### **Rye Neighbourhood Development Plan 2016-2028**

In view of your initial comments as Independent Examiner of the Rye Neighbourhood Plan, received on Monday 18 February 2019, Rother District Council (RDC) has prepared responses to questions 3,4,5,6,7,9,10,11,12,13,14,16. Discussions have taken place with the Rye NP representative in relation to issues raised in the Initial Comments document and these are reflected in our responses.

### **RYE TC NP Comments (Version 4 March 2019)**

**RYE NEIGHBOURHOOD PLAN**  
**RTC proposed Development Boundary amendment**

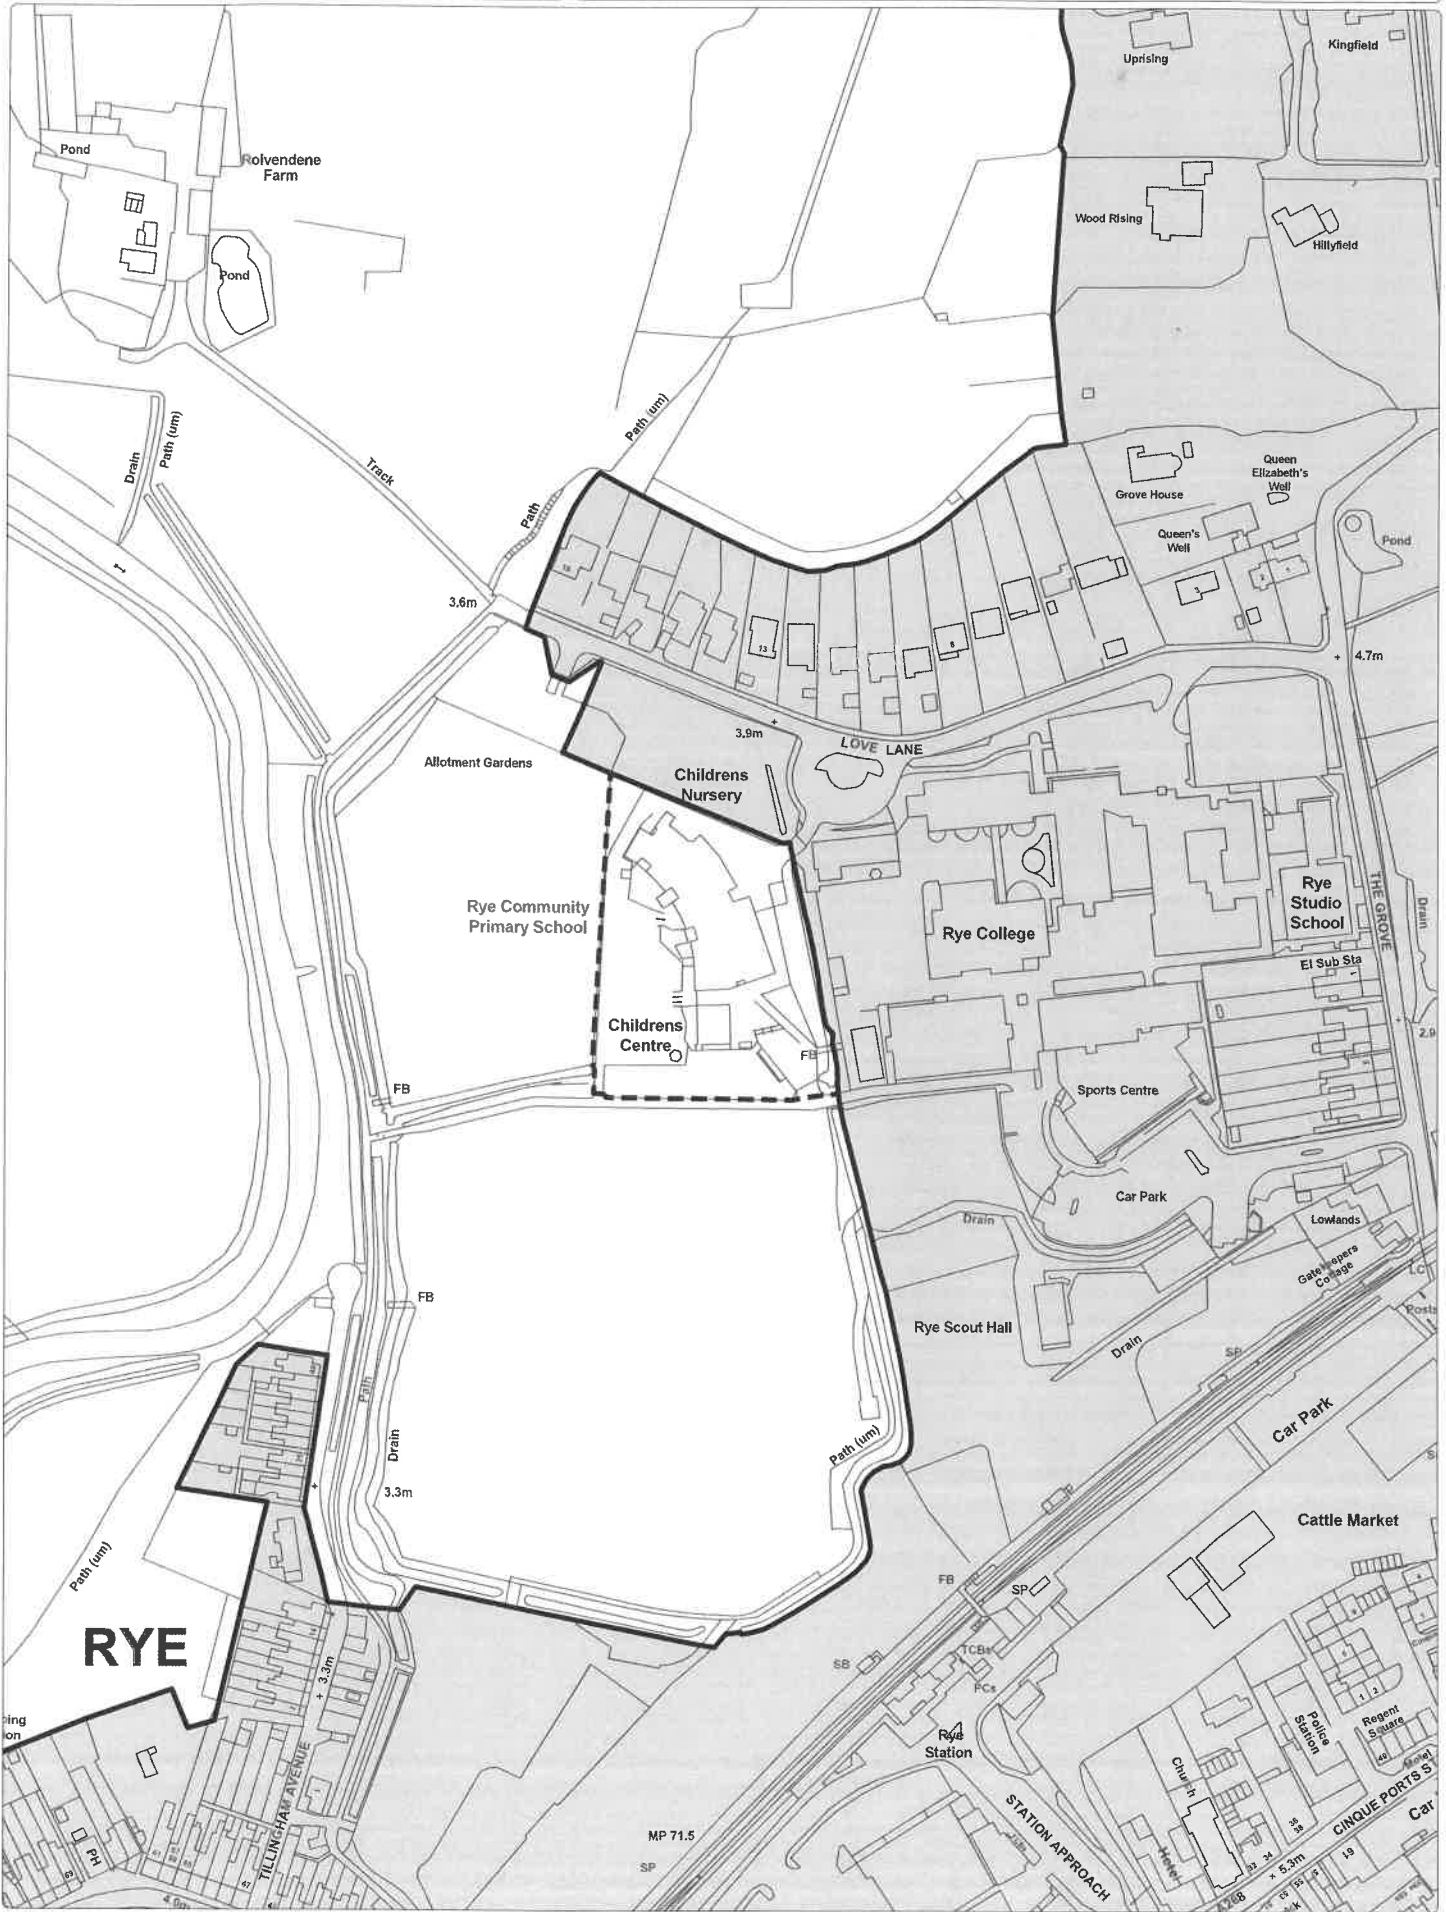
**P15** (Rye) Minor amendment to the development boundary in Figure 2 to include the new Primary School.

**KEY**  Submission Rye NP Development Boundary  RTC proposed Development Boundary amendment to include Primary School
